ADDENDUM

Date Issued:	April 8, 2019
Project:	Intermountain Healthcare IMC- Cath Lab #6 Remodel 5121 South Cottonwood Street Murray, Utah 84107
Addendum Number:	1

ADDENDUM #1

PROJECT: IMC Bldg 5 L1 Cath Lab #6 Remodel

MECHANICAL DEMOLITION PLAN

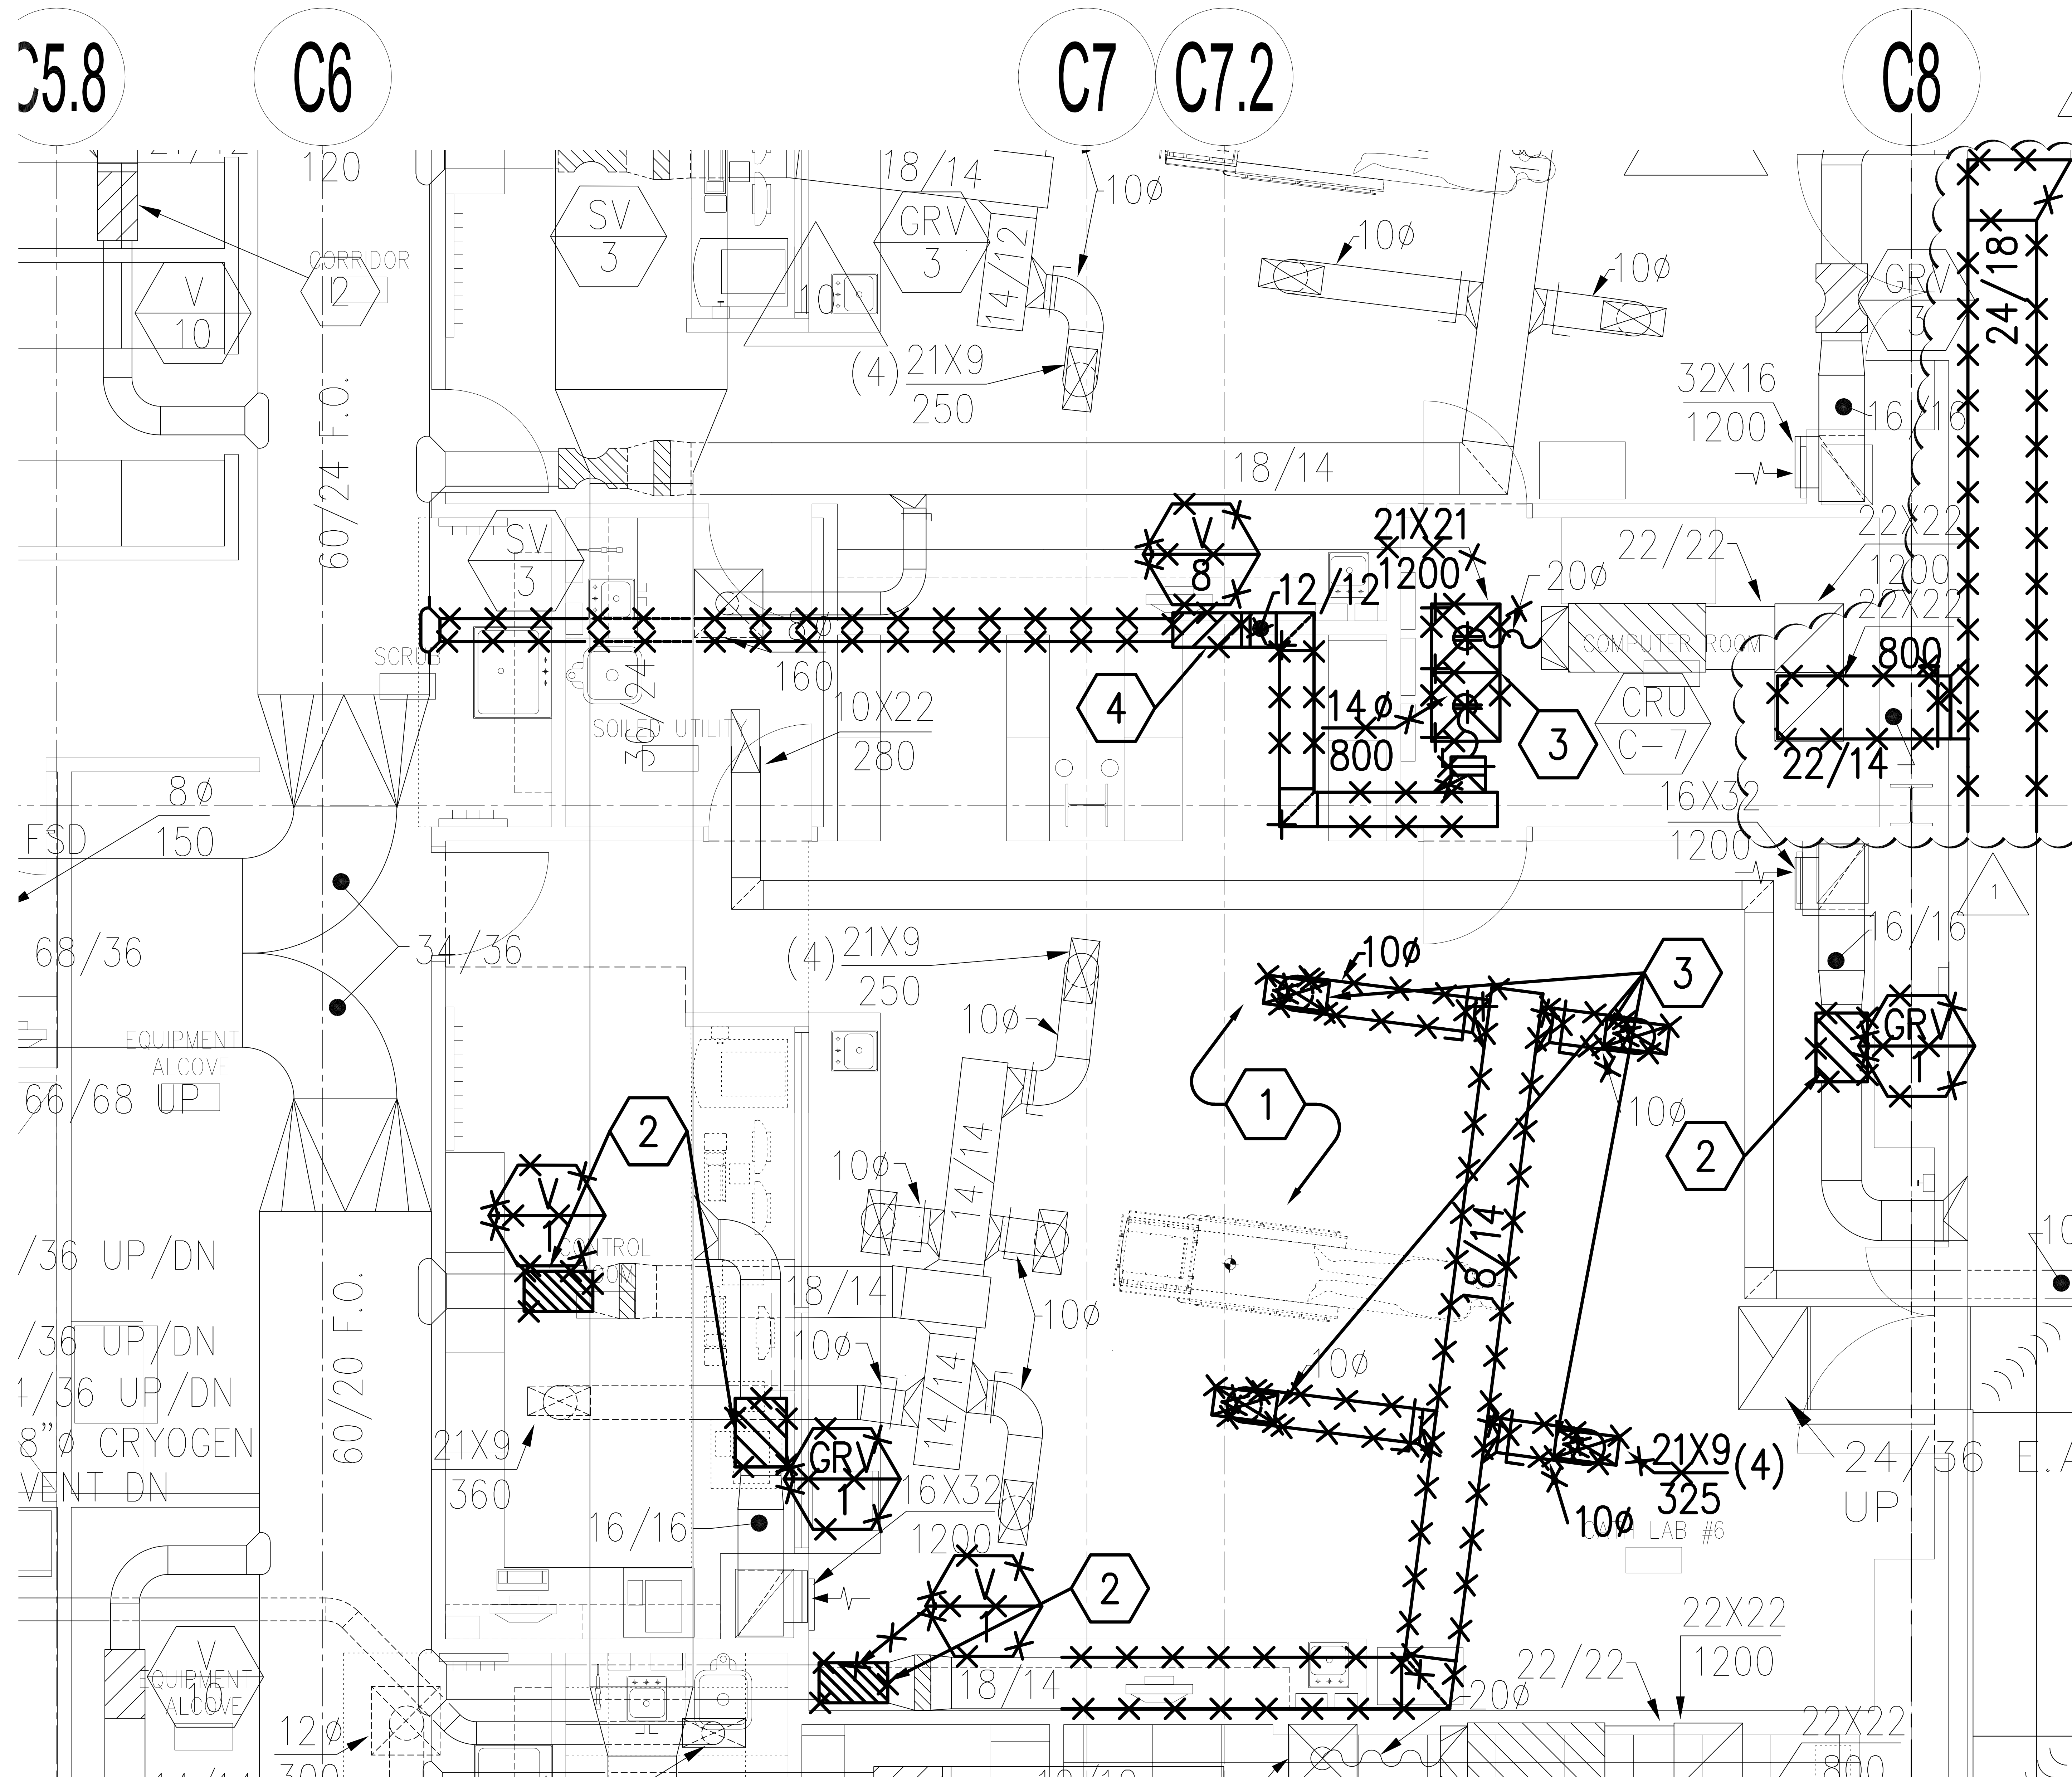
SHEET - M101 – Mechanical Demolition Plan

1. Keyed note revised.
2. Demolish return air ductwork and return air grille in computer room.

1 MECHANICAL PLAN
SCALE: 1/2" = 1'-0"

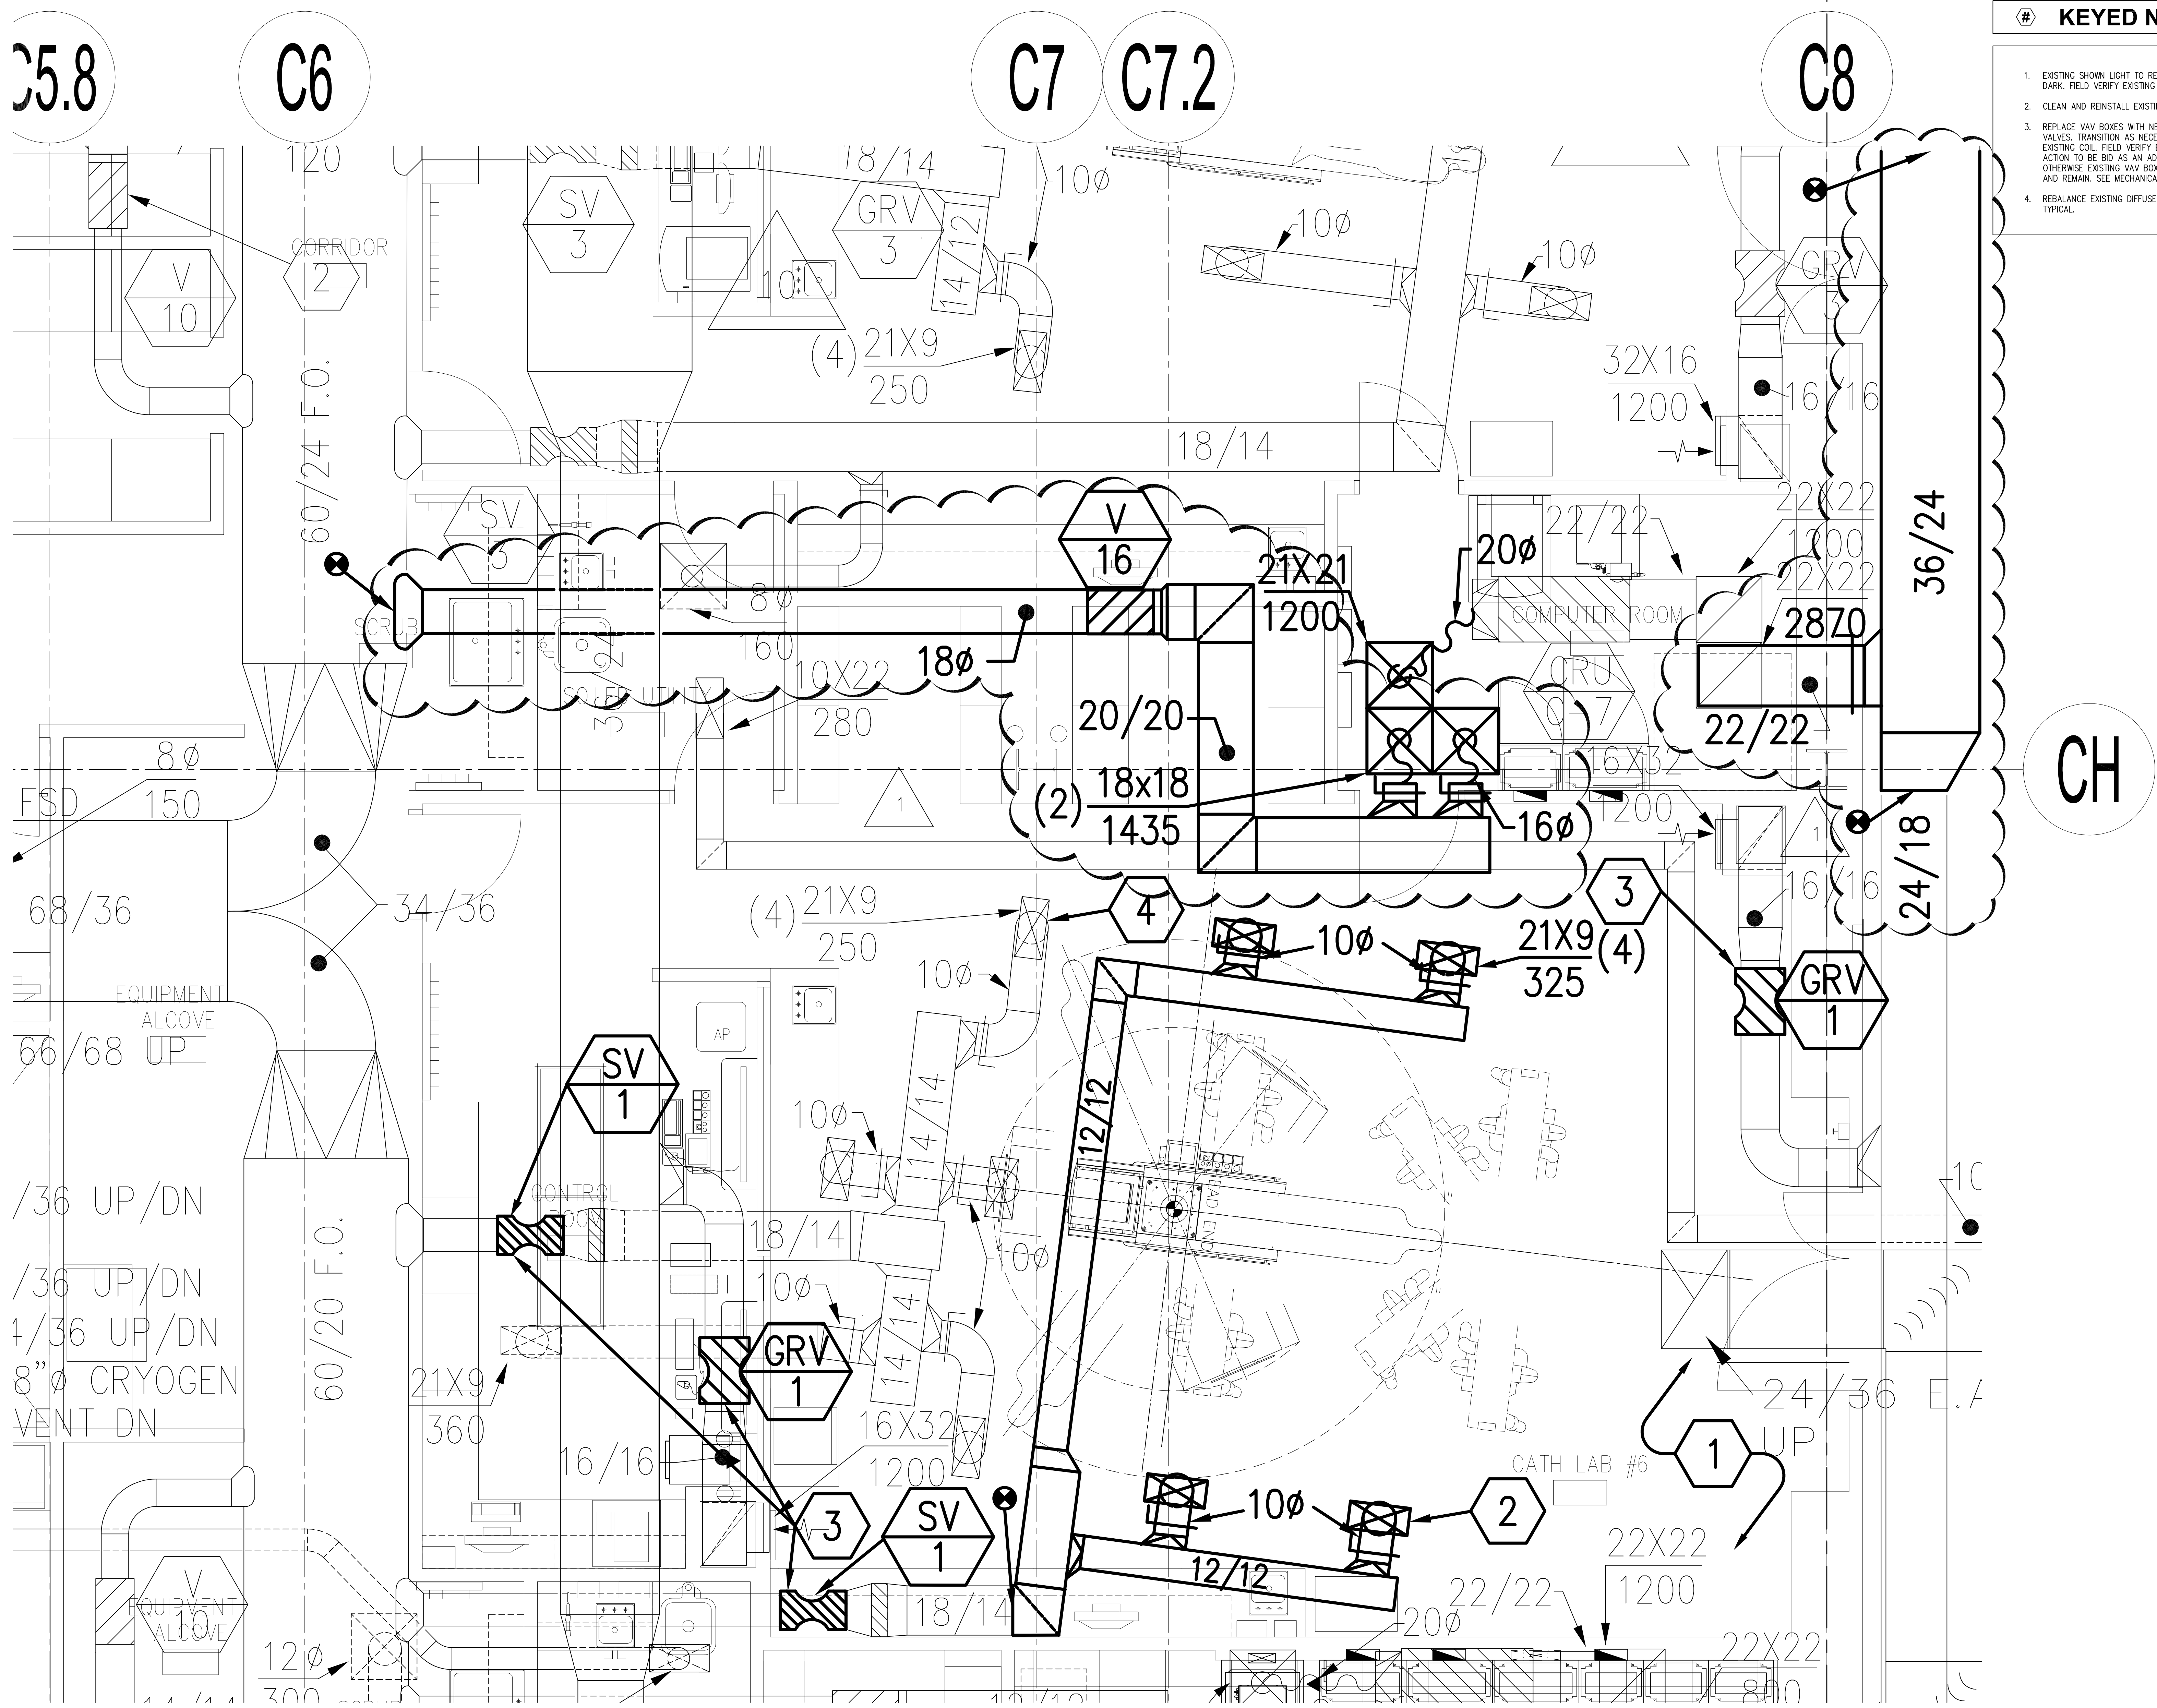
SHEET - M111 – Mechanical Plan

1. Changed VAV from size 12 to 16.
2. Install new supply and return air ductwork in computer room.
3. Rebalanced supply and return air in computer room.

1 MECHANICAL PIPING PLAN
SCALE: 1/2" = 1'-0"

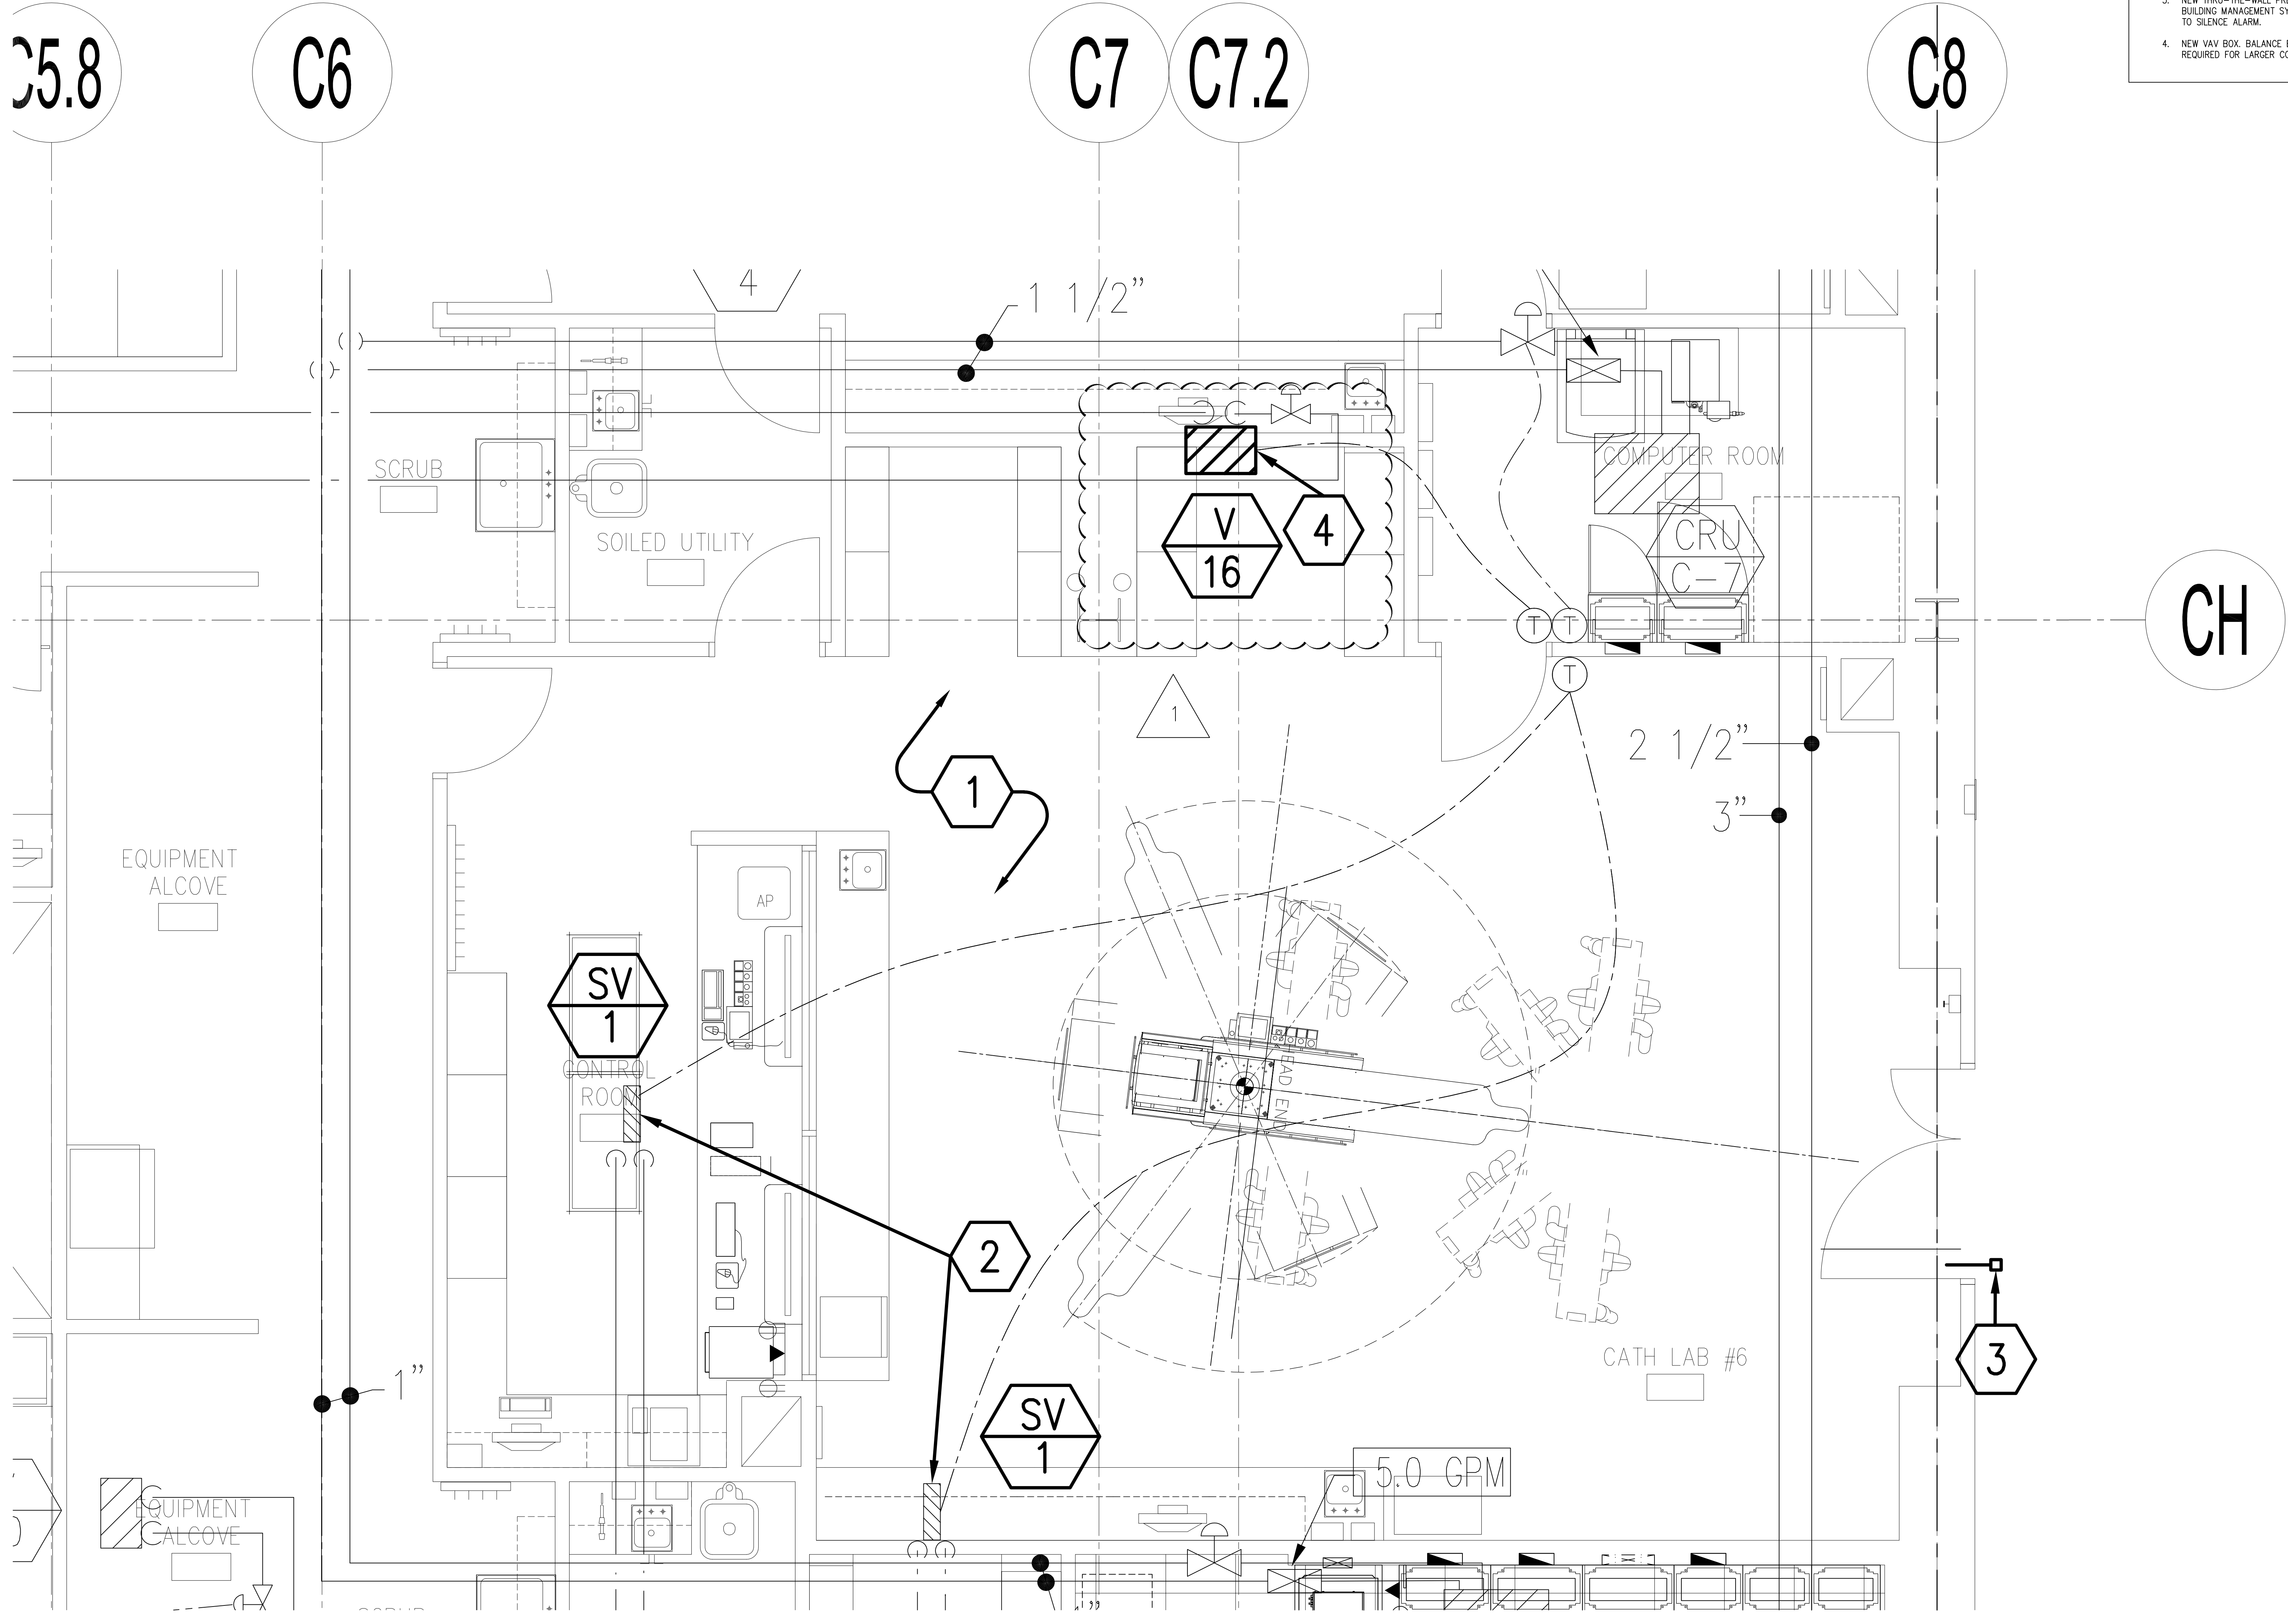
SHEET - M211 – Mechanical Piping Plan

1. Changed VAV from size 12 to 16.
